Sundry Print Report

Well Name: COMANCHE 25-36 FED STATE COM

Sundry ID: 2866863

Procedure Description: APD Change for: WELL NAME, SHL, CASING/CEMENT, FORMATION, BOP DESIGN, NGCP Well Name Change from Comanche 25 36 Fed State Com 10H (API 30-025-51243) (APD ID 10400080979) to Comanche 25 36 Fed Com 551H SHL Location change from : 290 FNL & 1445 FEL to 300 FNL & 1471 FEL CASING/CEMENT - Changes in Attached Drilling plan FORMATION change from Wolfcamp to Bone Spring BOP DESIGN- Changes in attached drilling plan NGCP - Updated plan attached

ACREAGE DEDICATION PLATS

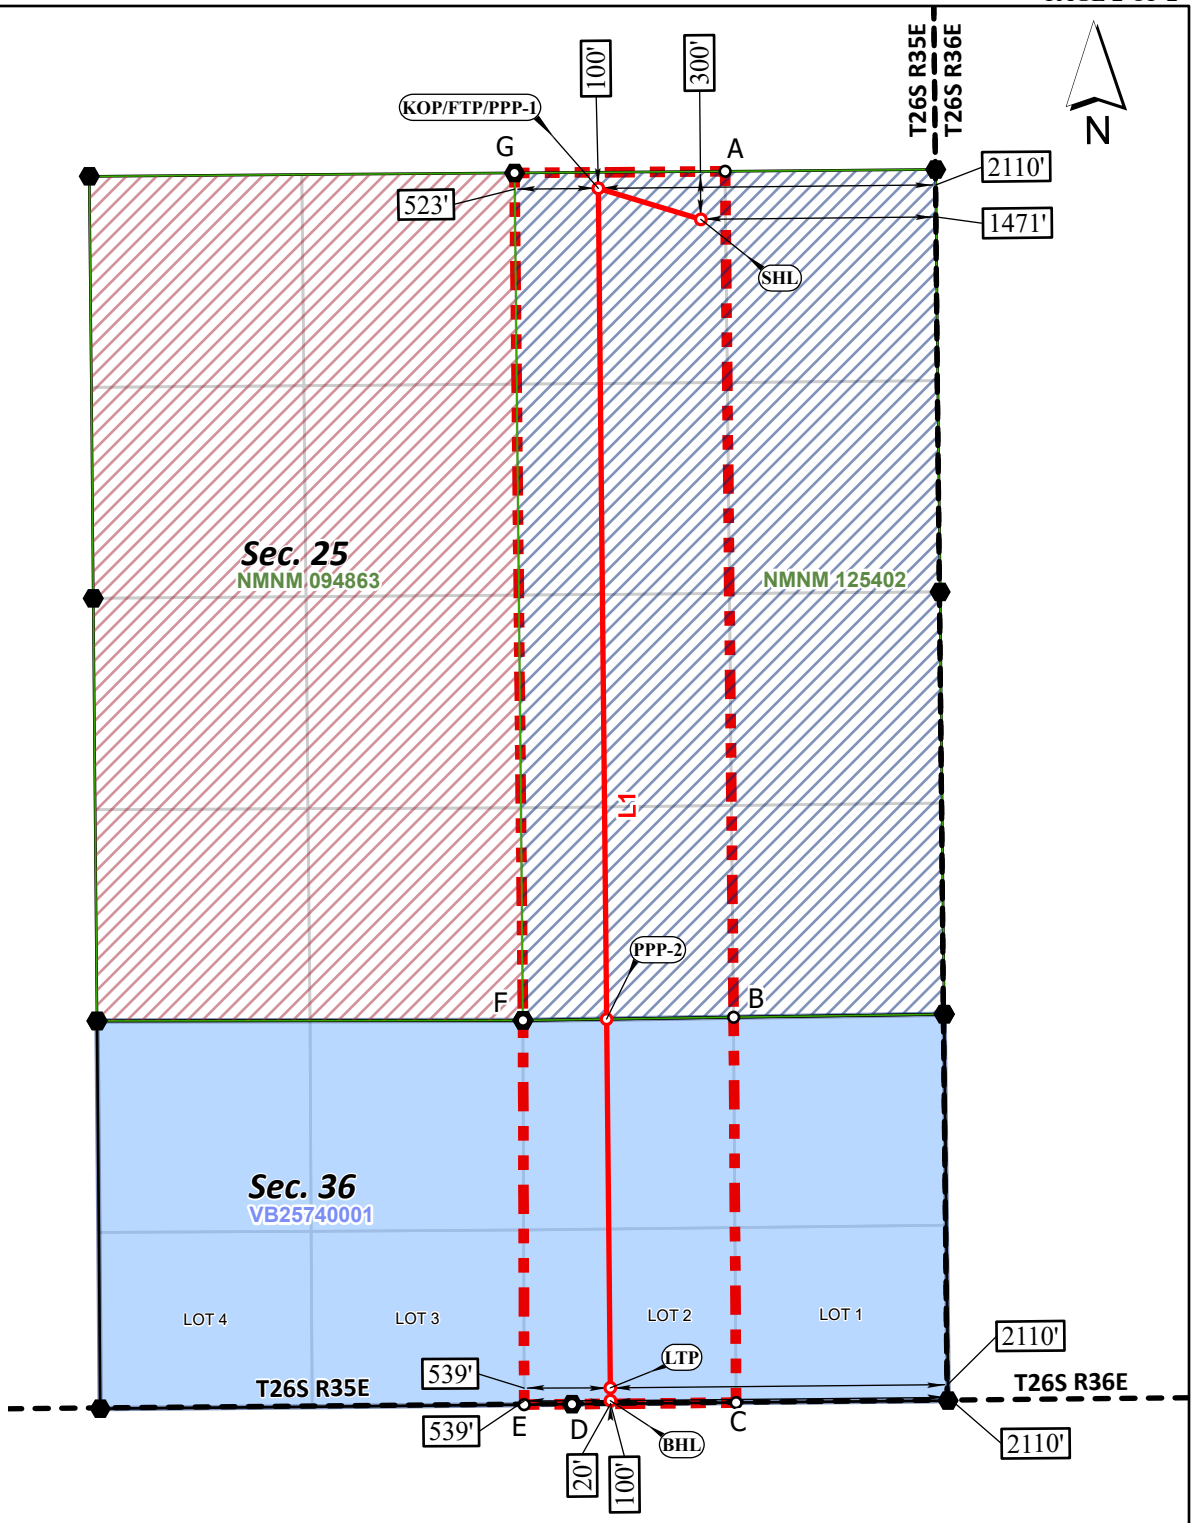
API Number	Pool Code	Pool Name
30-025-51243	~~98143~~ 98355	WC-025 G-07 S263525B;BONE SPRING ~~WC-025 G-09 S263527D; BONE SPRING~~

Property Code	Property Name	Well Number
~~337273~~ 337804	COMANCHE 25-36 FED COM	551H
